Access Compliance Report

Public Rights-of-Way

(Curb Ramps)

Intersection ID: N/A	Main Street: PINEVILLE-MATTHEWS_RD	Cross Street: COURTSIDE_LN	Location: N
ADA ID: FD936402609D	Ramp Type: Perp	Initial Pass/Fail: Fail	Overall Compliance: No
Codes/Mitigation Info/Possible Solution		Field Measurements/Component Compliance	
Severity Score: 12.5

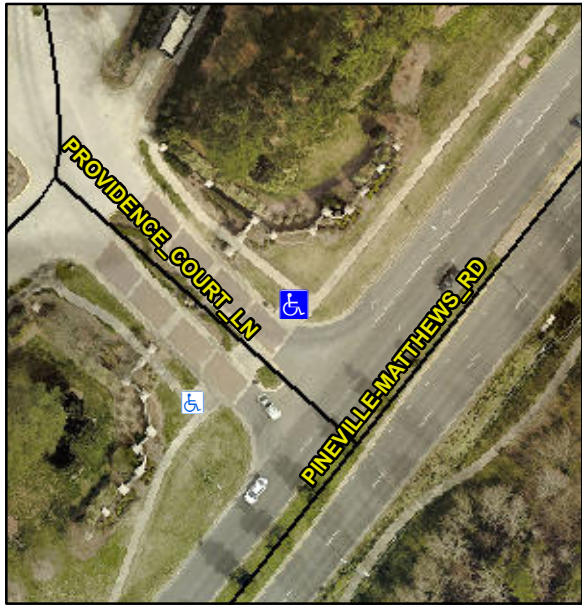
R304.5.3

Compliance	Description	Data	Compliance	Description	Data
N/A	Ramp Length (in)	130.0	Yes	Ramp Slope (%)	5.4
Yes	Ramp Width (in)	65.0	No	Ramp XSlope (%)	6.3
N/A	Flare Type LT	N/A	N/A	Flare Type RT	N/A
N/A	Flare Slope LT (%)	N/A	N/A	Flare Slope RT (%)	N/A
N/A	Flare Traversable LT?	N/A	N/A	Flare Traversable RT?	N/A
N/A	Landing Length (in)	N/A	N/A	DWS Provided?	N/A
N/A	Landing Width (in)	N/A	N/A	DWS Contrast?	N/A
N/A	Landing Slope (%)	N/A	N/A	DWS Length (in)	N/A
N/A	Landing X Slope (%)	N/A	N/A	DWS Full Width?	N/A
N/A	Landing Curb? (Y/N)	N/A	N/A	DWS Offset (in)	N/A
N/A	Shared Landing?	N/A			
N/A	Gutter Ponding?	N/A	N/A	Gutter Slope (%)	N/A
N/A	Gutter Lip Ht (in)	N/A	N/A	Gutter X Slope (%)	N/A
N/A	Painted X Walk1?	No	N/A	Painted X Walk2?	N/A
	X Walk 1 Direction	To SW		X Walk 2 Direction	N/A
N/A	X Walk 1 Width (in)	N/A	N/A	X Walk 2 Width (in)	N/A
	X Walk 1 Slope (%)	1.0		X Walk 2 Slope (%)	N/A
	X Walk 1 X Slope (%)	3.6		X Walk 2 X Slope (%)	N/A

Remove & Replace Entire Ramp.
